**TO:** Planning Commission  
**FROM:** Jennifer Irvine P.E. MPA, County Engineer/ECM Administrator  
**DATE:** June 2, 2020  
**RE:** Engineering Criteria Manual (ECM) Revisions

These revisions include a new chapter specific to ADA Accessibility guidelines and the associated revisions throughout the ECM for consistency and updated standard drawings are summarized in the attachments.

This request is for the Planning Commission to recommend approval of the proposed new chapter and the associated attached administrative revisions to the El Paso County Engineering Criteria Manual to the Board of County Commissioners.

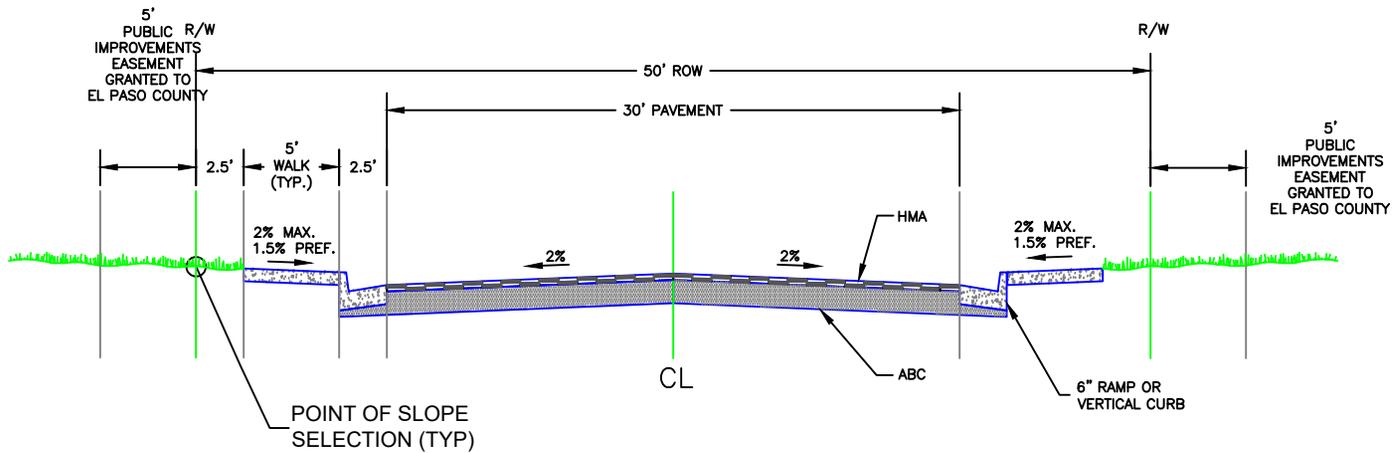
5.10.6.B	5-69	Revise second bullet: "pedestrian facilities and curb ramps".	Recommended	Expand to include sidewalks and other pedestrian facilities.
<b>ECM Appendix F</b>	SD_2-1 - SD_2-9		Add cross slope over sidewalk as 2% max. (1.5% preferred)	Recommended	Provide room for construction tolerance.
	SD_2-20		Gutter cross slope exceeds 5%. Add note to flatten at curb ramps	Required	Required for compliant counterslope at curb ramps.
	SD_2-24		Modify to provide 4' min. sidewalk width at the flared portion of sidewalk. Modify cross slope to show 2% max. (1.5% preferred). Add note to comply with ECM Chapter 6.	Recommended	Provide room for construction tolerance.
	SD_2-25		Modify to provide 4' minimum sidewalk width across driveway. Modify cross slope to show 2% max. (1.5% preferred). Add note to comply with ECM Chapter 6.	Recommended	Provide room for construction tolerance.
	Curb Ramps		Add language in ECM Chapter for other ramp designs permitted by PROWAG, and reference/utilize CDOT standard details if they are not found in EPC App F.	Recommended

Pedestrian Curb Ramp Detail  
Standard Drawing

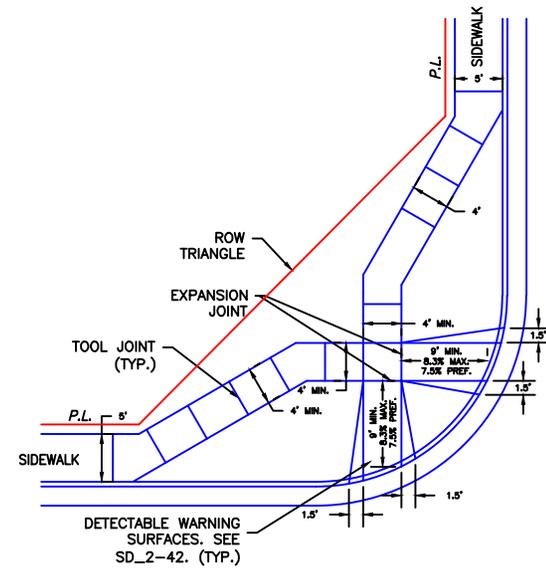
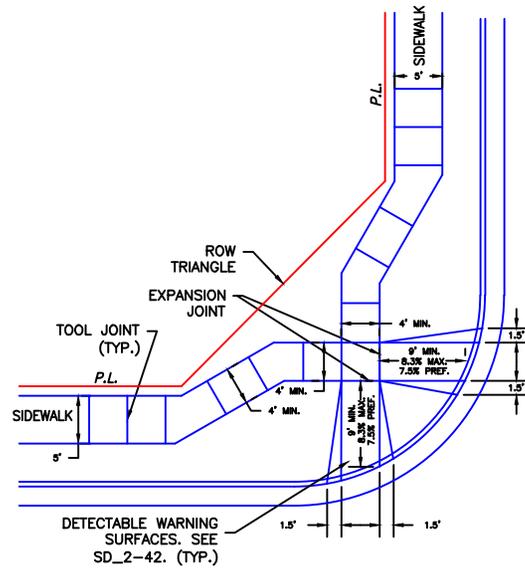
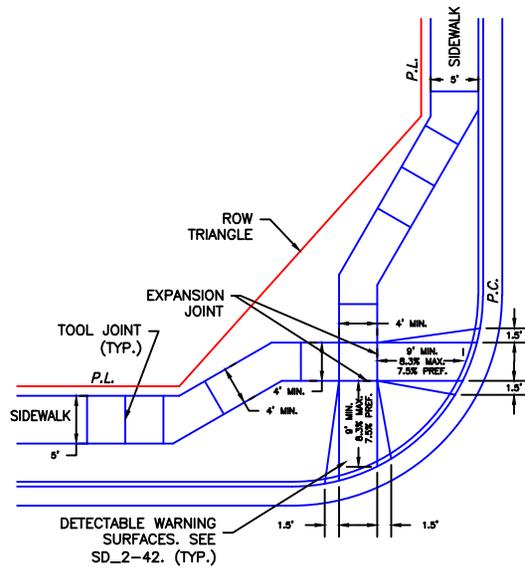
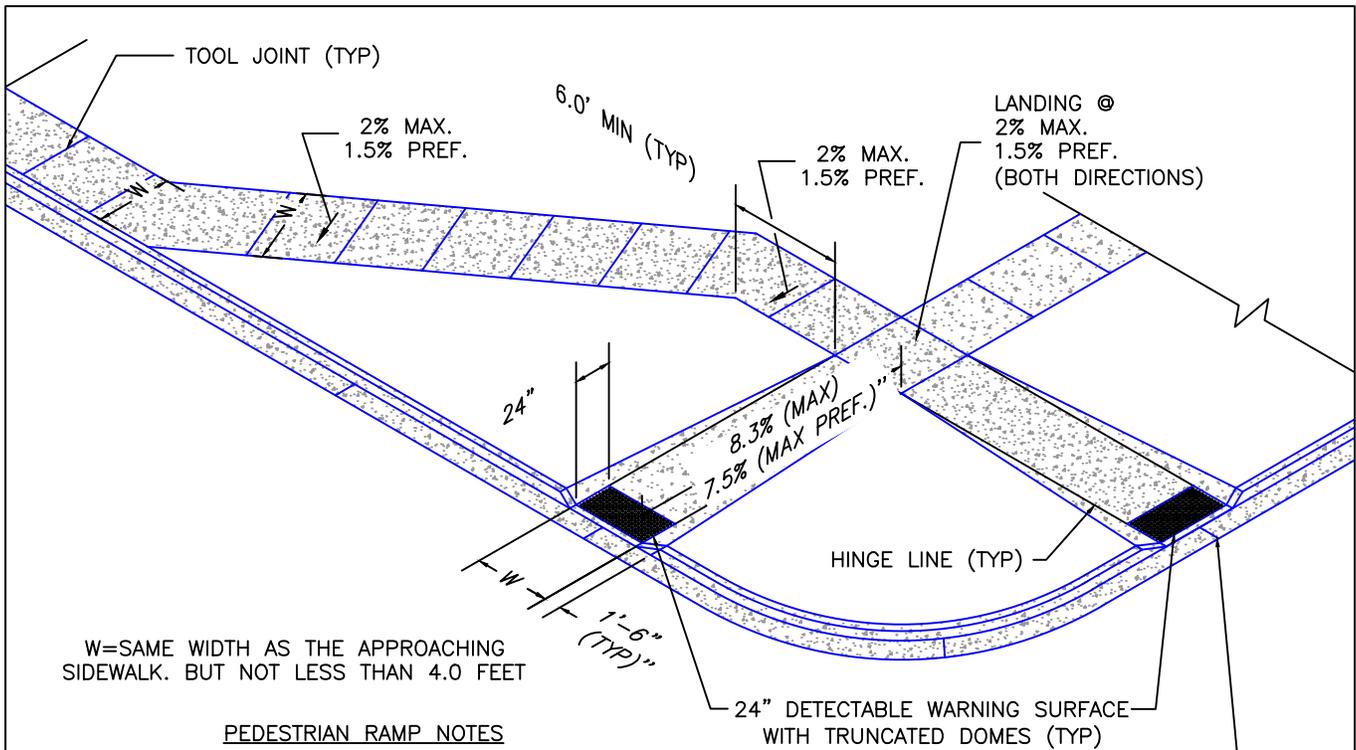
SD_2-40		Change name to Pedestrian Curb Ramp Detail. Modify to provide 4' min. sidewalk width at the flared portion of sidewalk. Modify cross slope to show 8.3% max. (7.5% preferred). Change name to Detectable Warning Surfaces and refer to SD_2-42.	Recommended	Utilize current standard drawings, direct designers in ECM to propose other site specific designs if standard designs are not feasible-

<p>6/23/20</p> <p>DATE APPROVED:</p> <p>Jennifer E. Irvine</p> <p>DEPARTMENT OF PUBLIC WORKS</p>	<p>Pedestrian Curb Ramp</p> <p>Standard Drawing</p>	<p>P:\M-Stds and Other Details\logo3dbutton.jpg</p>
	<p>REVISION DATE:</p> <p>6/23/20</p>	<p>FILE NAME:</p> <p>SD_2-41</p>

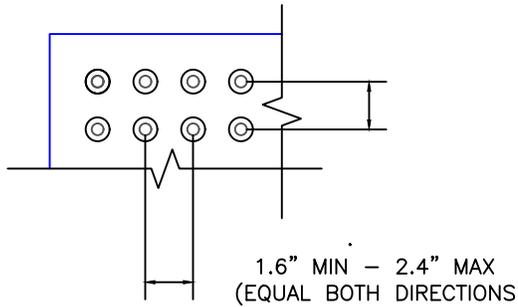
Revisions to other Documents/Sections Associated with new ECM Chapter 6 Accessibility					
Document	Section	Page	Recommended Revision	Required or Recommended	Potential Impacts
	SD_2-41		Change name to Pedestrian Curb Ramp Detail. Modify cross slope to show 2% max. (1.5% preferred) for sidewalk and landing. Modify running slope to show 8.3% max. (7.5% max preferred). Revise Note 4 to refer to Pushbutton Location per ECM. Change name to "Detectable Warning Surface" in multiple locations. Revise Note 6 regarding DWS to state the DWS should be prefabricated cast iron type. Revise Note 10 to state that drainage structures, traffic signal...are prohibited within ramp areas or landings. Add Note 11 to clarify 5% max. counter slope. In General Notes, add (Pedestrian Circulation Path) and (Pedestrian Access Route) for clarity. Change all instances to "Pedestrian Curb Ramp."	Required	Various revisions for consistency with Chapter 6. The County no longer uses the DWS mentioned in the standard and desires only cast iron type DWS.

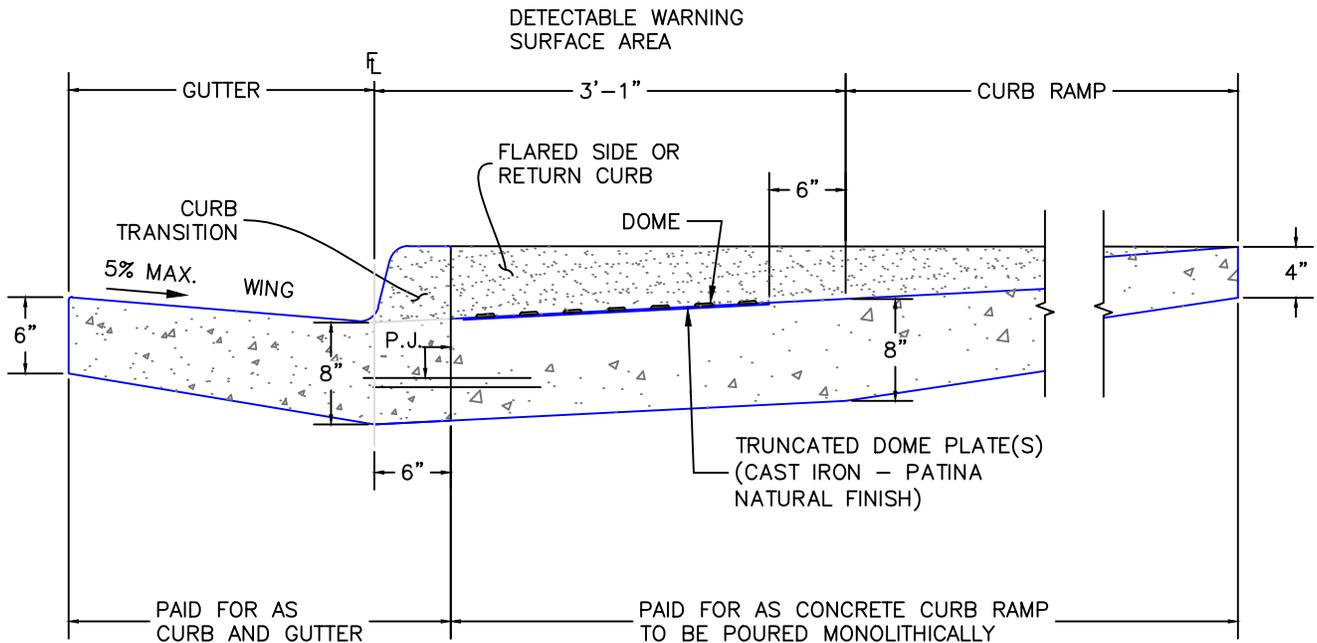
SD_2-42		Modify the DWS standard to be compliant with PROWAG and specify the material to be used as cast iron.	Recommended	Consistency with Chapter 6
	SD_2-50		Change name to Parallel Pedestrian Curb Ramp Detail. Modify cross slope to show 2% max. (1.5% preferred) for turning space. Modify running slopes to show 8.3% max. (7.5% max preferred). Modify DWS to show cast iron type.	Recommended	
<b>Design Checklists</b>					
			Add design checklists for pedestrian access routes and curb ramps.	Recommended	Provides designers and contractors with a way to verify their designs meet PROWAG requirements. Checklists will not be included in ECM or required as part of official project file. They will be available as a recommended tool during project development.
<b>EPC Land Dev. Code</b>	5.2.36.D.1.i.	5-49	Add bullet: "Method for accommodating pedestrians" to requirements for Traffic Control Plan	Recommended	Consistency with Chapter 6
